August 9, 2011

RE: ASHTABULA COUNTY
HARPERSFIELD TOWNSHIP
GENEVA INDOOR SPORTS PARK
NPDES PERMIT NO. OHC000003
OHIO EPA PERMIT NO. 3GC05051*AG
CONSTRUCTION STORM WATER

Figure 2. Some of the catch basins are missing grates.

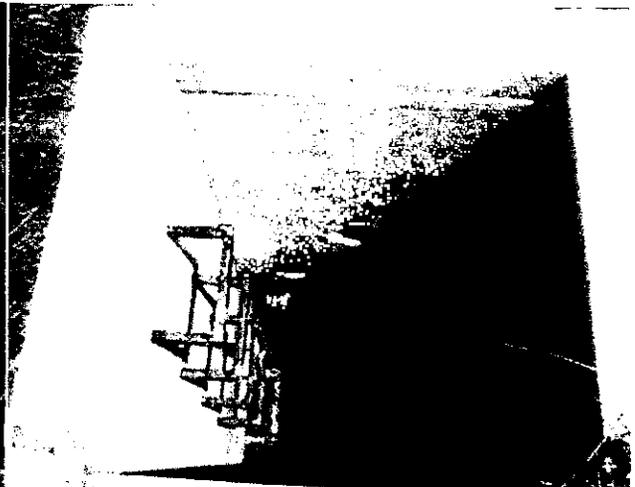
- *The catch basins for the sediment basins are missing grates.*
 - Please be sure to install grates on the catch basins as soon as possible (See Figure 2).
